Access Compliance Report Public Rights-of-Way (Curb Ramps)

Main Street: SHELTON_CT Cross Street: STERLING_GLEN Location: NE

ADA ID: RPAT211101135327 Ramp Type: Type 4 - Parallel Initial Pass/Fail: Fail Overall Compliance: No Severity Score: 32

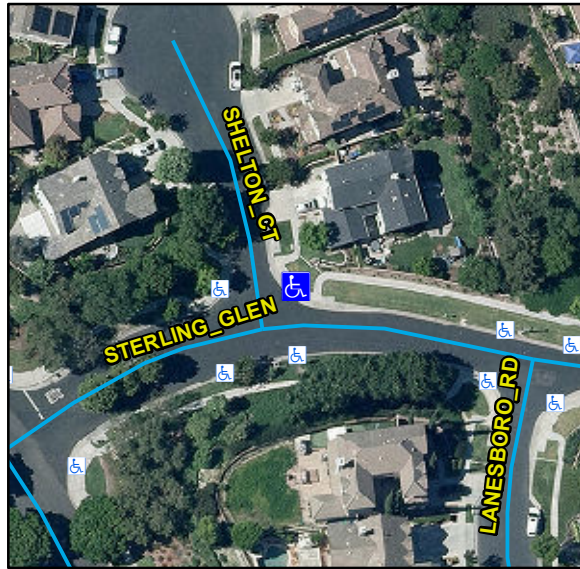
R204.3, R304.5.3, R304.3.2, STD 1115

Remove & Replace Curb Ramp With Two New Directional Ramps or Equivalent.
